CALL NO. 100
CONTRACT ID NO. 241306
ADDENDUM # 1

Subject: Breathitt County, NHPP 0151 (090)
Letting March 21, 2024

- (1) Added - Traffic Management Plan - Pages 583A-583L of 649
- (2) Revised - Plan Sheets U-039, U-041, U-042, U-044, U-045, U-047

Sheet No.	U-039
City of Jackson - Utility Relocation	BREATHITT COUNTY, KY - KY15, ITEM NO. 376.00
Date	2023-08-17
Drawn By	JCM
Scale	AS SHOWN
Job No.	933.40

CITY OF JACKSON
 UTILITY RELOCATION
 BREATHITT COUNTY, KY - KY15
 ITEM No. 10-376.00
 COURT STREET LIFT STATION DETAILS

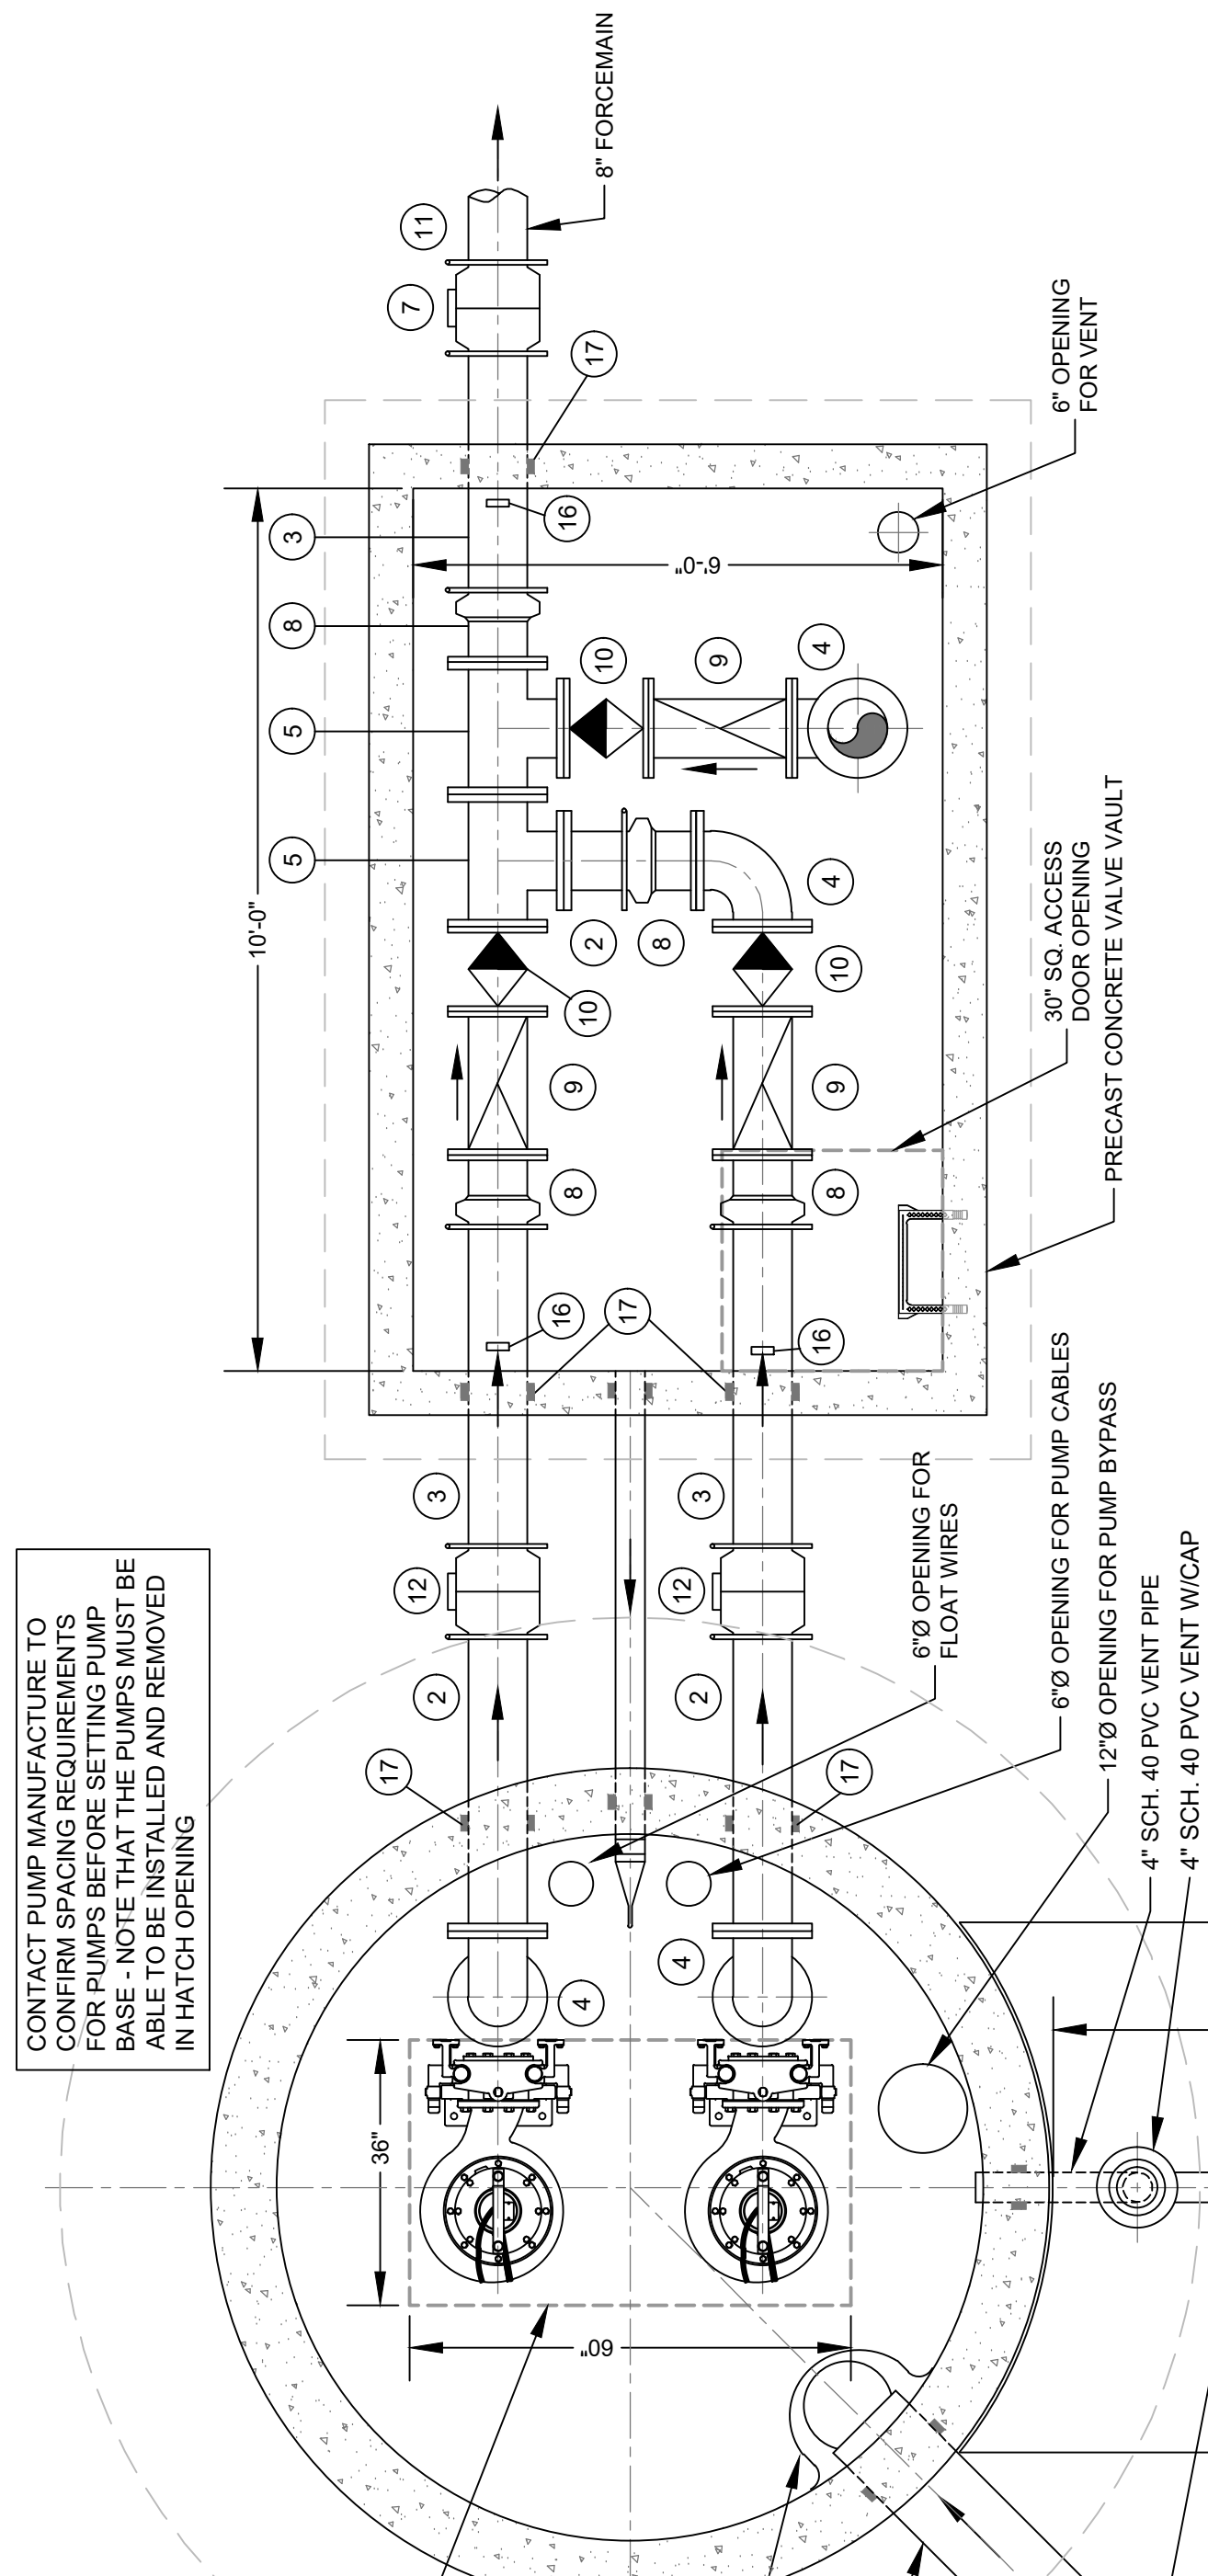
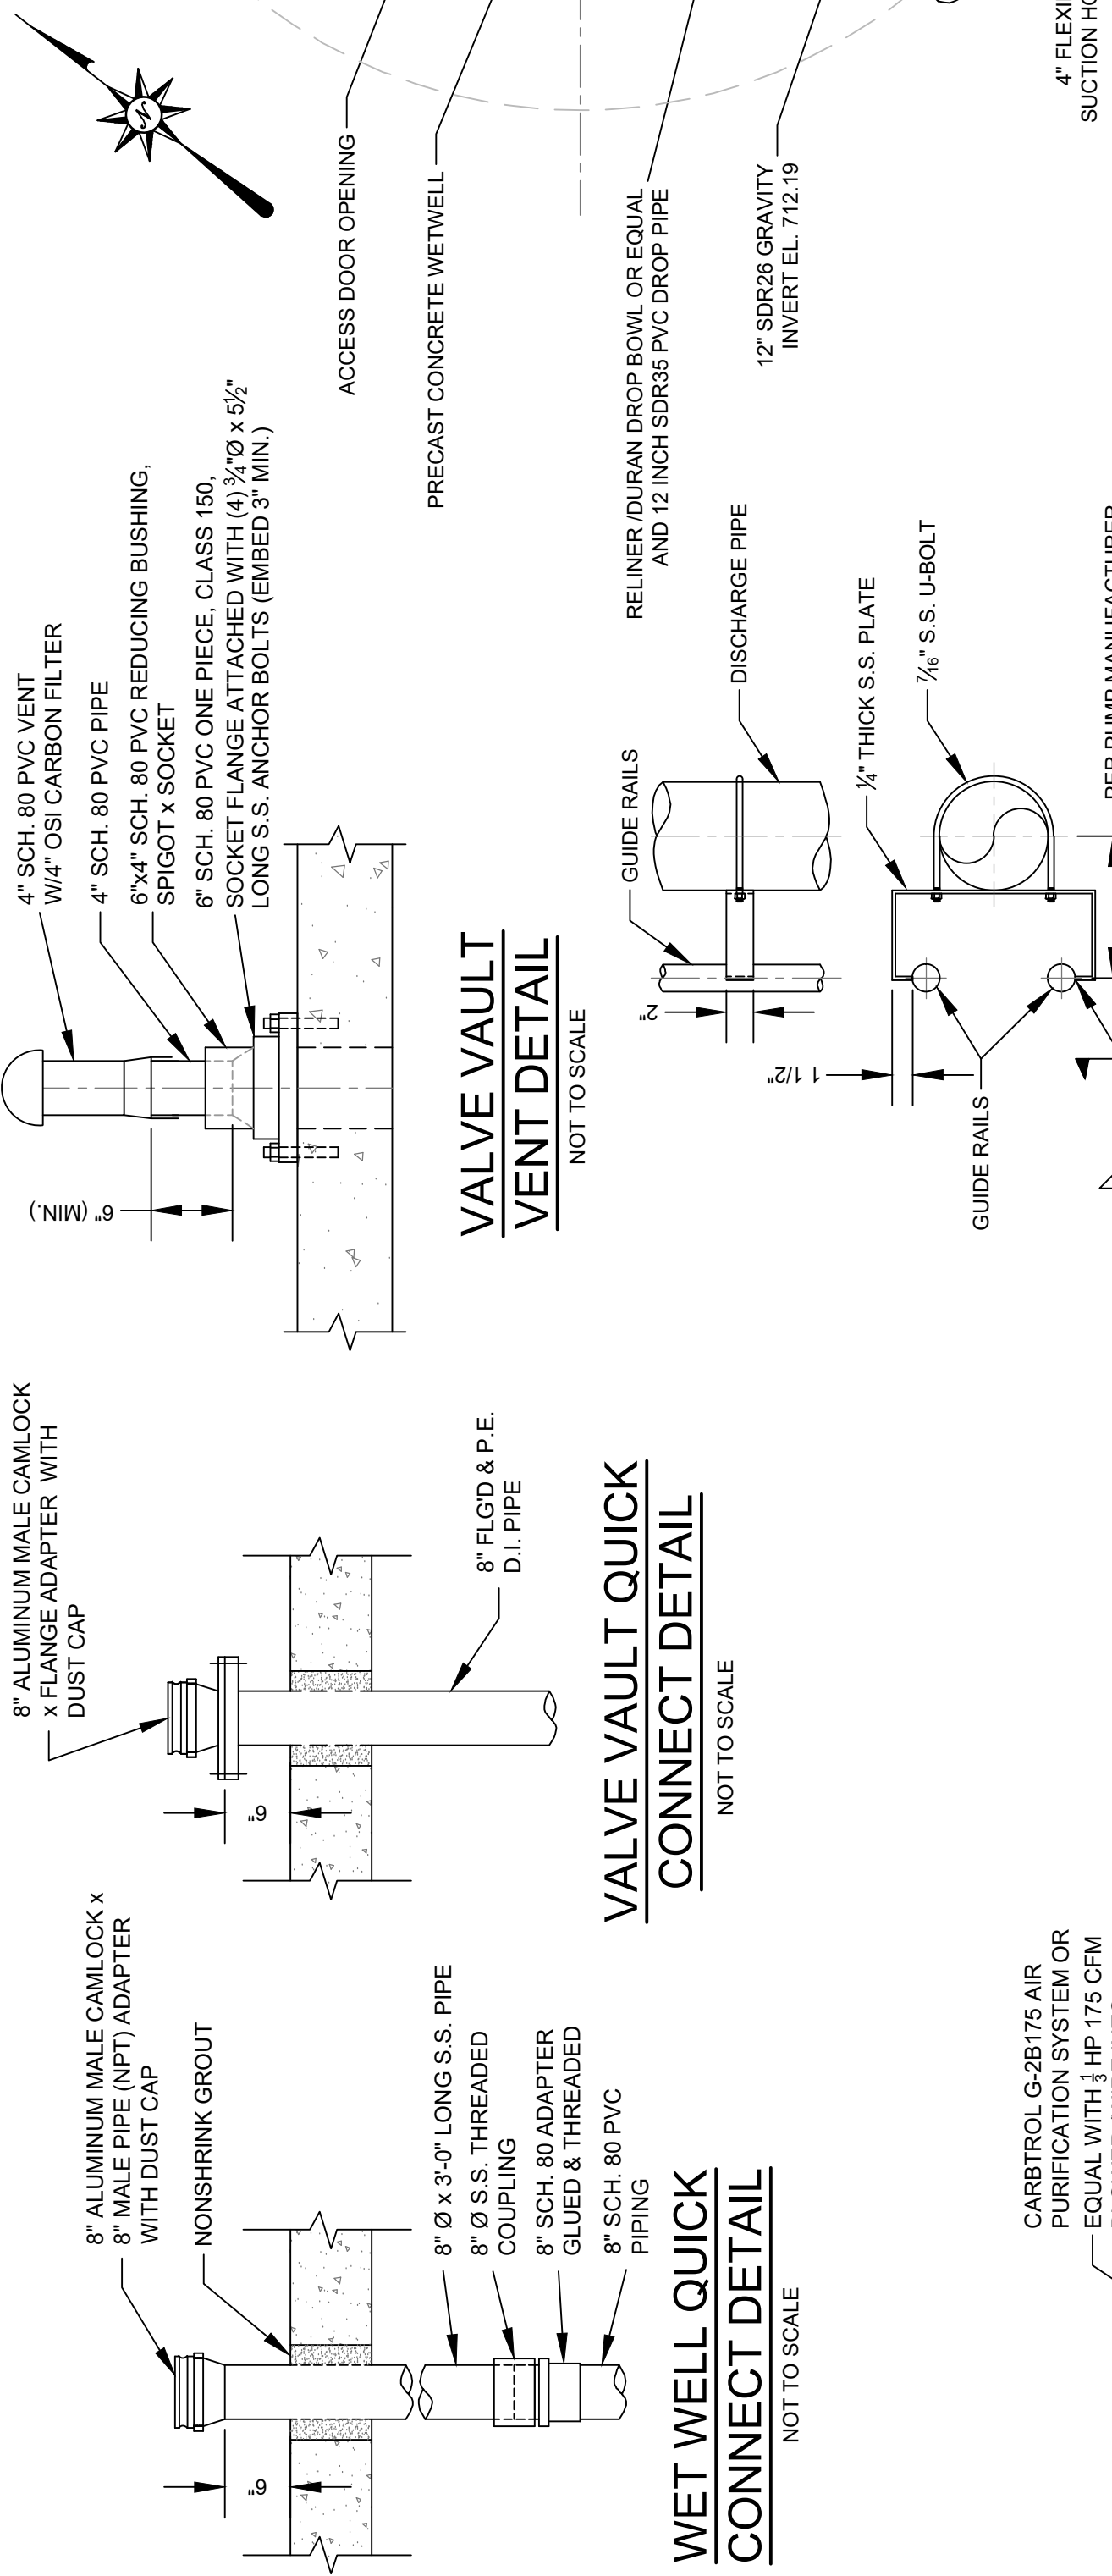
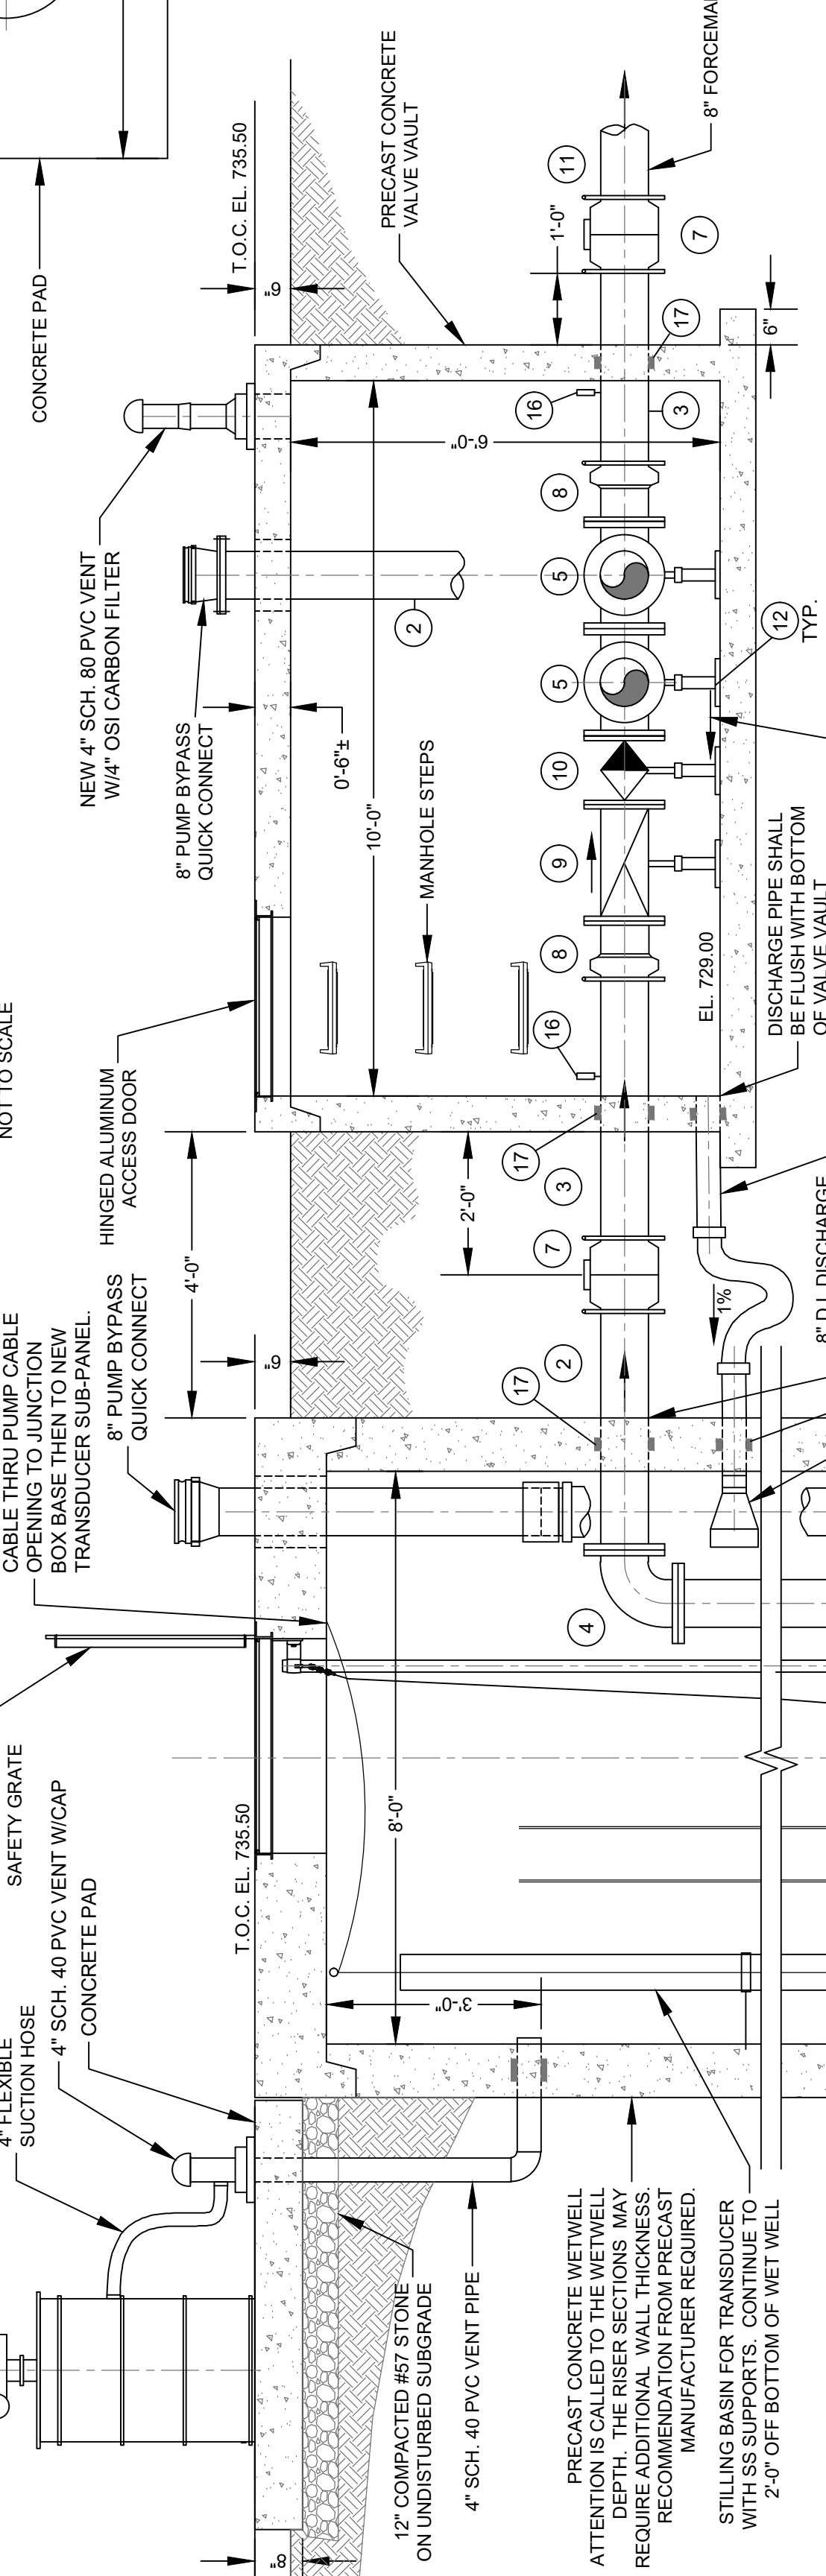
2023-11-17 R1 RELOCATED VALVE VAULT DRAIN TO DISCHARGE INTO WET WELL (JCW)
 2024-02-20 ADD 1 CHANGE TO GATE VALVE IN LIFT STATION
